Access Compliance Report

Public Rights-of-Way

(Curb Ramps)

Intersection ID: 52612	Main Street: GRAHAM RIDGE DR	Cross Street: ALEXANDER VILLAGE MAIN DR	Location: SW
ADA ID: 0D2583651755	Ramp Type: Perp	Initial Pass/Fail: Fail	Overall Compliance: No
Severity Score: 12.5			
Codes/Mitigation Info/Possible Solution		Field Measurements/Component Compliance

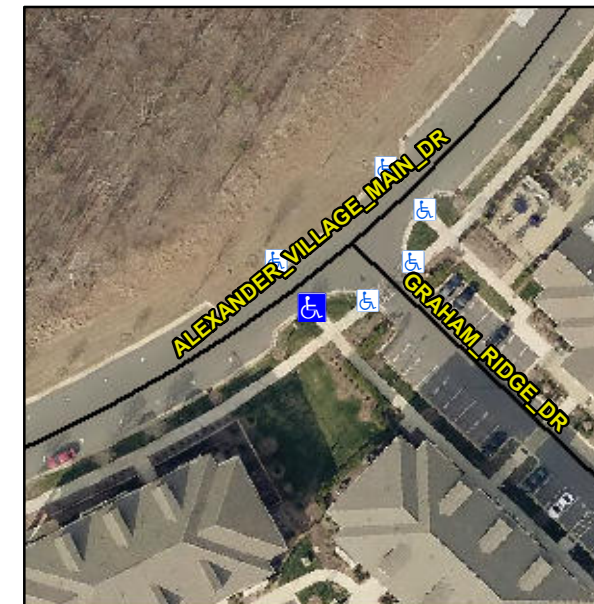
R304.2.2

Compliance	Description	Data	Compliance	Description	Data
N/A	Ramp Length (in)	93.0	No	Ramp Slope (%)	9.5
Yes	Ramp Width (in)	70.0	Yes	Ramp XSlope (%)	1.8
N/A	Flare Type LT	N/A	N/A	Flare Type RT	N/A
N/A	Flare Slope LT (%)	N/A	N/A	Flare Slope RT (%)	N/A
N/A	Flare Traversable LT?	N/A	N/A	Flare Traversable RT?	N/A
N/A	Landing Length (in)	N/A	N/A	DWS Provided?	N/A
N/A	Landing Width (in)	N/A	N/A	DWS Contrast?	N/A
N/A	Landing Slope (%)	N/A	N/A	DWS Length (in)	N/A
N/A	Landing X Slope (%)	N/A	N/A	DWS Full Width?	N/A
N/A	Landing Curb? (Y/N)	N/A	N/A	DWS Offset (in)	N/A
N/A	Shared Landing?	N/A			
N/A	Gutter Ponding?	N/A	N/A	Gutter Slope (%)	N/A
N/A	Gutter Lip Ht (in)	N/A	N/A	Gutter X Slope (%)	N/A
N/A	Painted X Walk1?	No	N/A	Painted X Walk2?	N/A
	X Walk 1 Direction	To NW		X Walk 2 Direction	N/A
N/A	X Walk 1 Width (in)	N/A	N/A	X Walk 2 Width (in)	N/A
	X Walk 1 Slope (%)	2.2		X Walk 2 Slope (%)	N/A
	X Walk 1 X Slope (%)	2.6		X Walk 2 X Slope (%)	N/A

Remove & Replace Entire Ramp.
